**FINAL DRAFT  
REPORT**

**Clarksburg - Ten Mile Creek Area  
Sewer Facility Study**

Washington Suburban  
Sanitary Commission

March 2, 2015

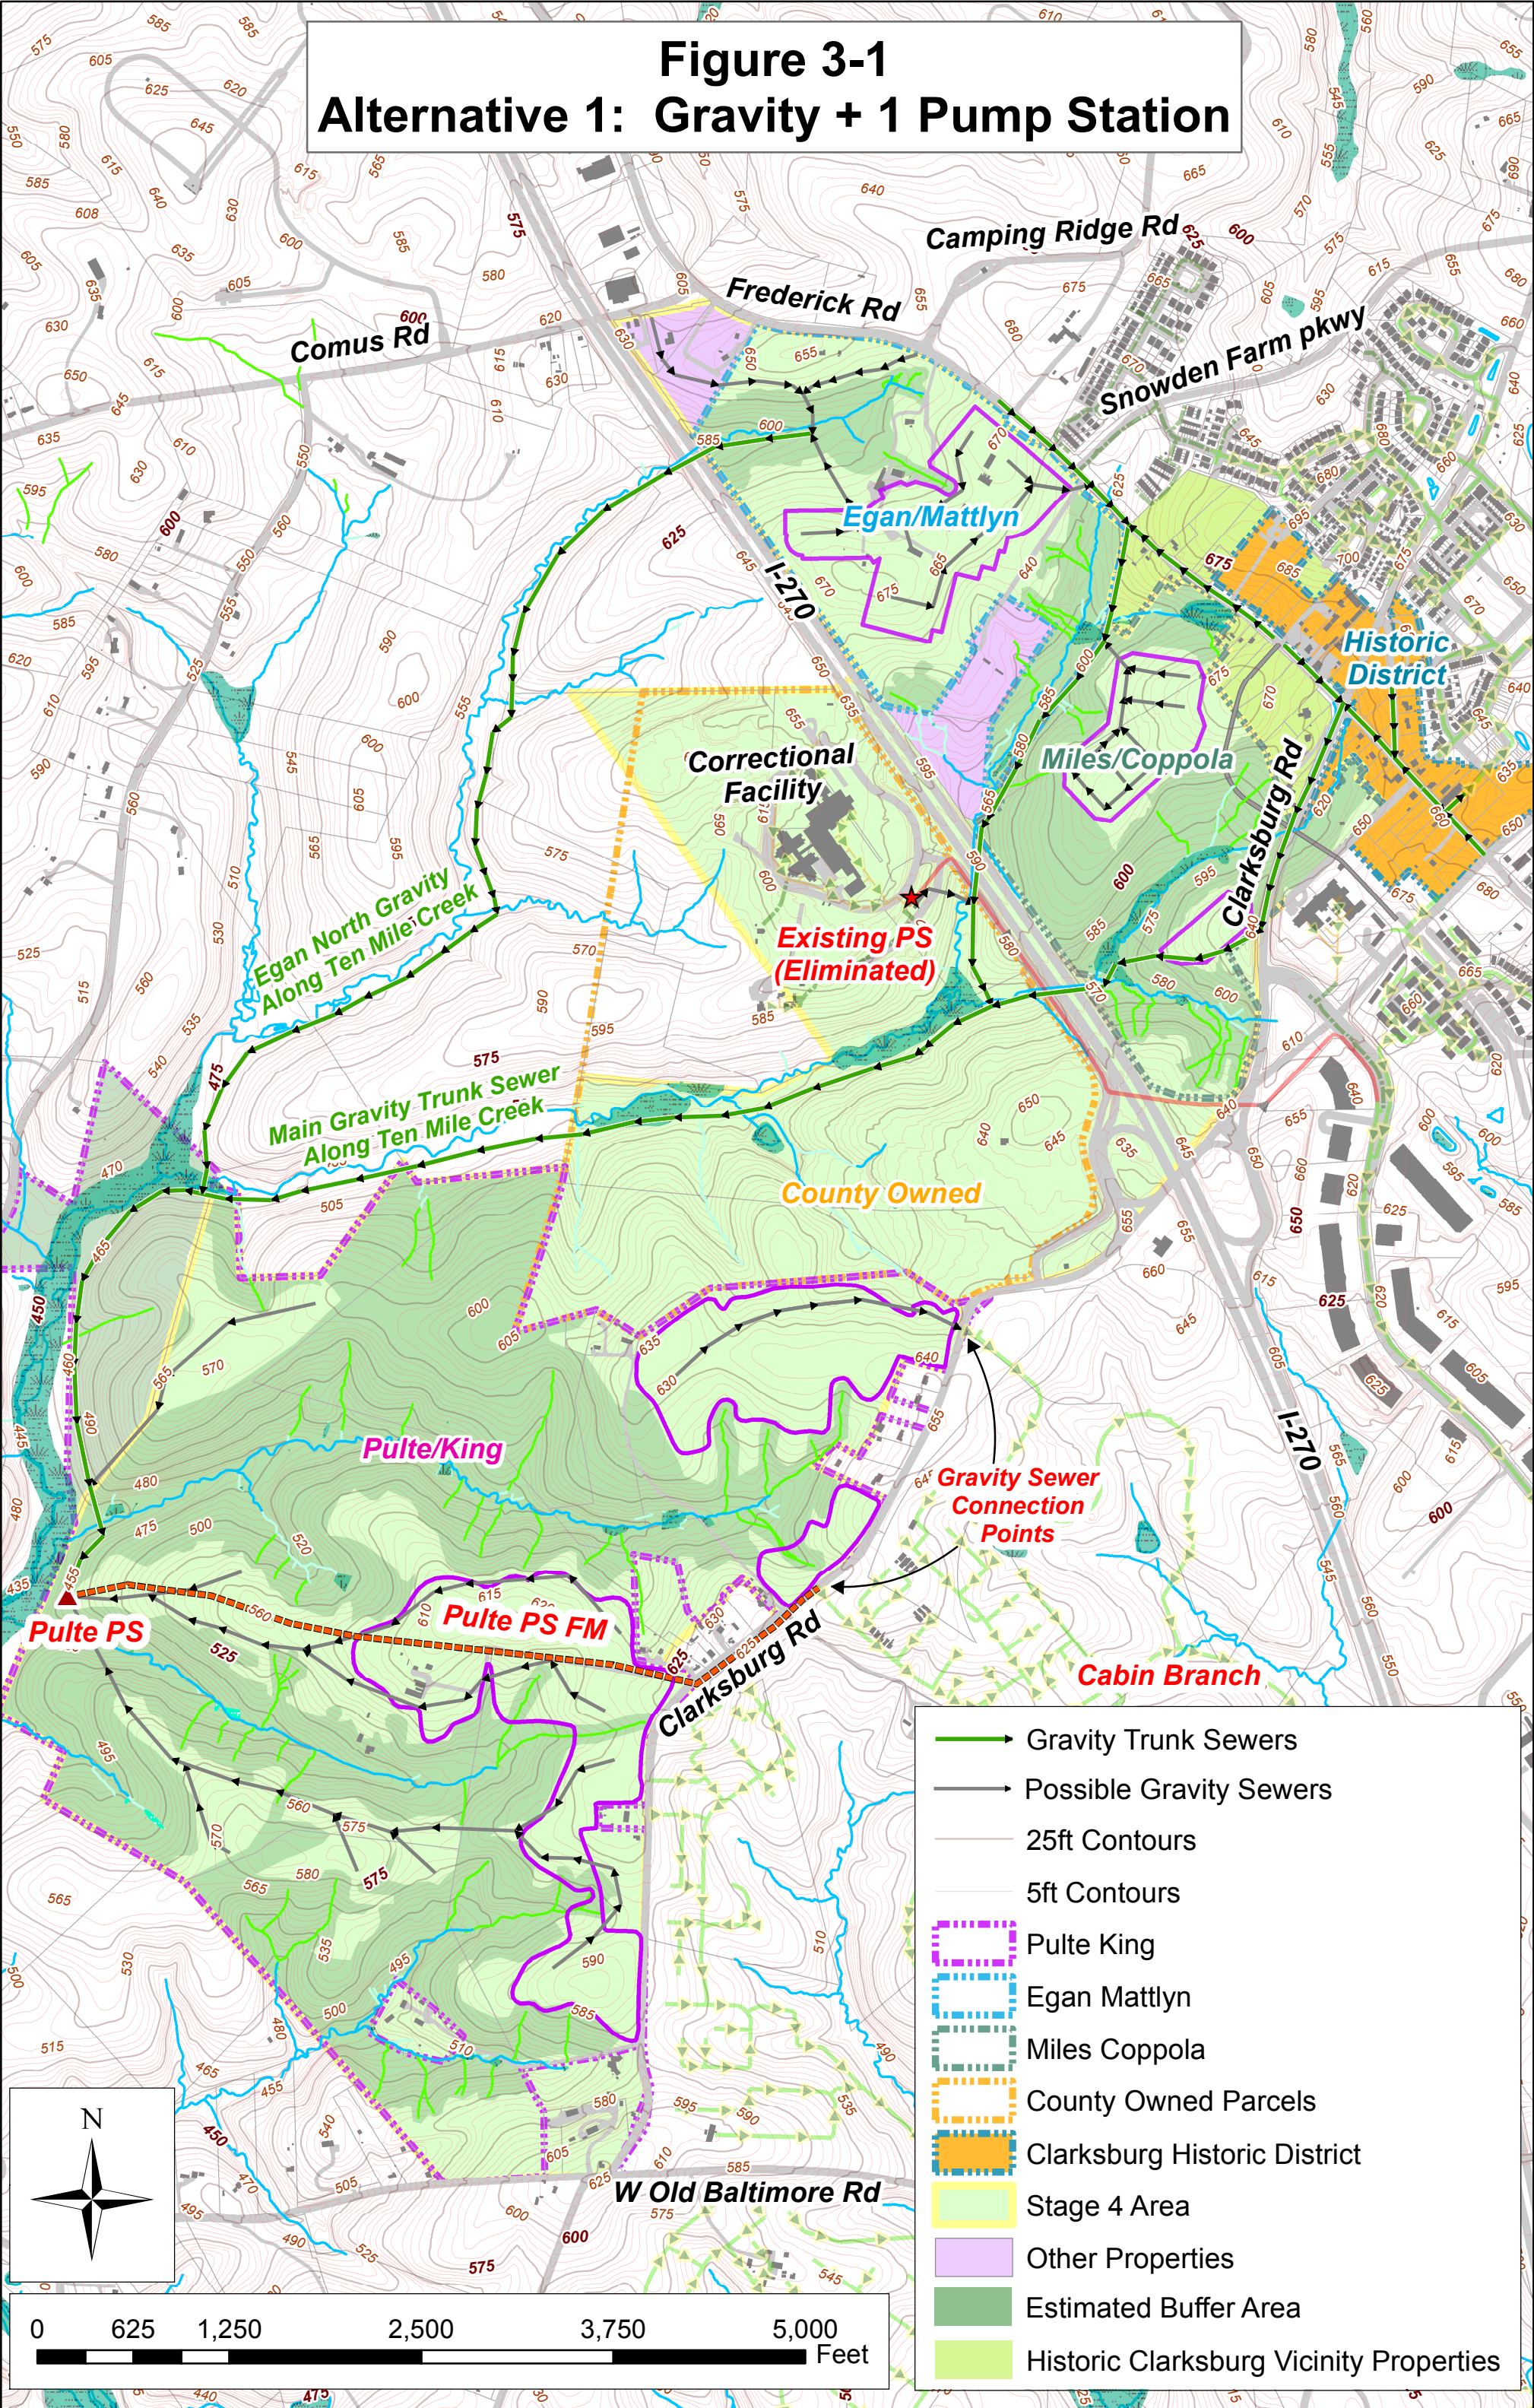
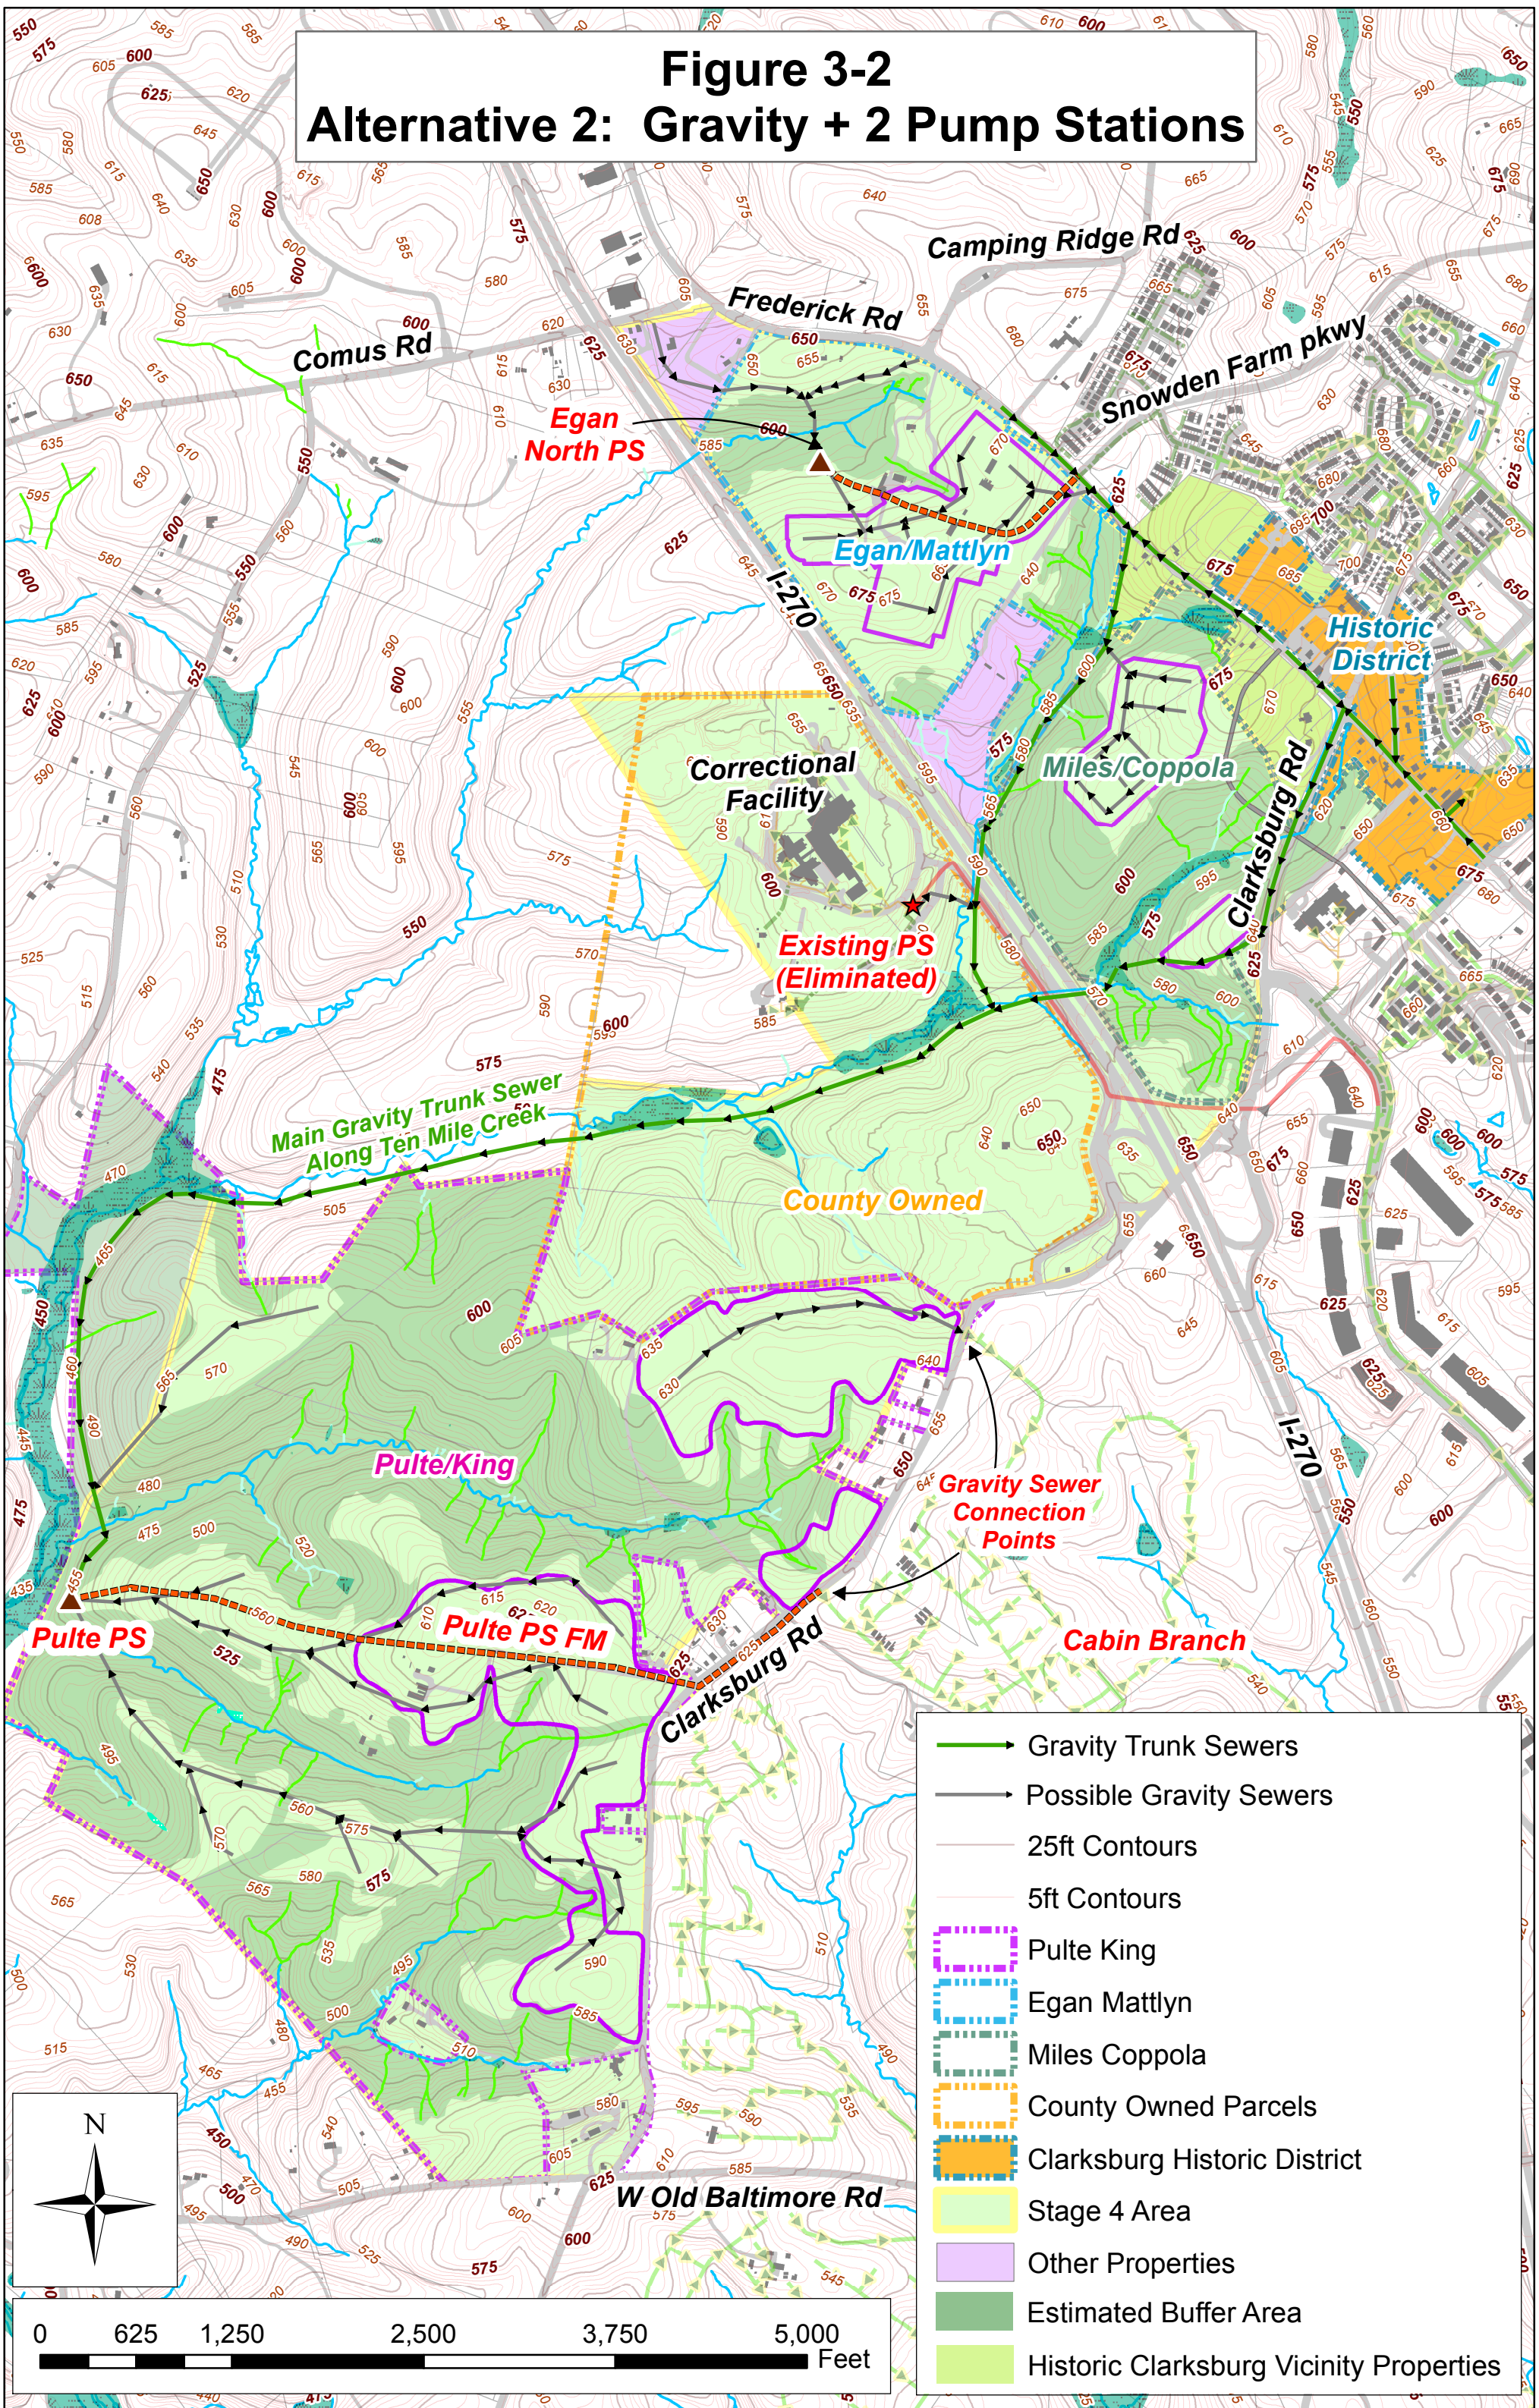
40	12/18/2015	Jay Cinque, Anne James, Cathy Wiss, (CAC Members)	<p><b>5. Remaining sewer issues</b></p> <p><i>c) On the maps for each of the alternatives, sewers in the southern part of the Pulte property appear to stop abruptly. We understand that they will connect to planned sewers in the Cabin Branch watershed that have not yet been built. A notation of this planned connection would be helpful on Figures 1-2, 3-1 through 3-10, 4-3, and 4-4.</i></p>	<p>Revised figures 3-1 through 3-12 in the Final Draft Report to address the comment</p>
41	12/18/2015	Jay Cinque,	<b>5. Remaining sewer issues</b>

<b>46</b>	12/21/2015	Katherine E. Nelson Planner Coordinator M-NCPPC	<i>5. Figures 3-1 through 3-10 (the Alternatives) – These figures identify “Buffer Areas”. Since these buffer areas have not been determined yet, they should be identified as “anticipated” or “estimated” buffers. These figures should also identify all existing and future gravity sewer connection points on the east side of Clarksburg Road.</i>	Revised figures 3-1 through 3-12 in the Final Draft Report to address the comment
<b>47</b>	12/21/2015	Katherine E. Nelson Planner Coordinator M-NCPPC	<i>6. Tables 4-1 through 4-8, pages 4-2 through 4-5 – Long-term operation and maintenance should only include the O&amp;M that will be performed at PUBLIC expense. At the very least, the difference between public and private O&amp;M should be shown. This relates primarily to grinder pumps located in private homes.</i>	Cost tables in Section 4 of the Final Draft report were revised to provide additional clarity. Private capital and O&M expenses and the pump station to be built by WSSC are identified in the revised cost tables. Generally, infrastructure projects need to provide sewer service to a property is built by the developers. Some of these projects may be eligible to receive System Development Charge (SDC) credits. This is determined on a case to case basis. Identifying funding mechanisms for construction of the critical infrastructure needed to serve the entire project area is beyond the scope of this current sewer study. Long term O&M costs for pumping stations is borne by WSSC,
